CITY OF TORRANCE, CALIFORNIA

**ADDENDUM NO. 4
Issued: July 22, 2010**

**PROPOSAL, SPECIFICATIONS, BOND AND
AFFIDAVIT FOR THE CONSTRUCTION
OF
DEL AMO BOULEVARD EXTENSION, T-30
FEDERAL PROJECT NO. ESPLRSTP 5249-(021)
B2010-12**

2. Refer to the PLAN SHEETS S-106, S-107, S-110, & S-112 (sheets 71, 72, 75, and 76) Bearing Pad Dimensions.

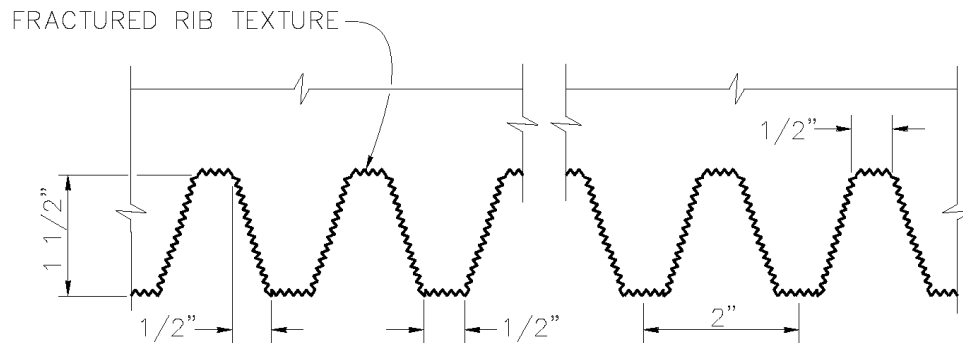
The various references on these plan sheets and listed shown below regarding the bearing pads are hereby deleted.

- 18" X 16" X 1" Elastomeric Reinforced Steel Bearing Pads: and
- Elastomeric Bearing Pad 18" X 14" X 1 1/2" Steel Reinforced Bearing Pad: and
- 18" X 14" X 1 1/2" Steel Reinforced Bearing Pad

Add the following reference on these plan sheets to replace the above-deleted references regarding the bearing pads

18" X 12" X 2.5" Elastomeric Reinforced Steel Bearing Pads
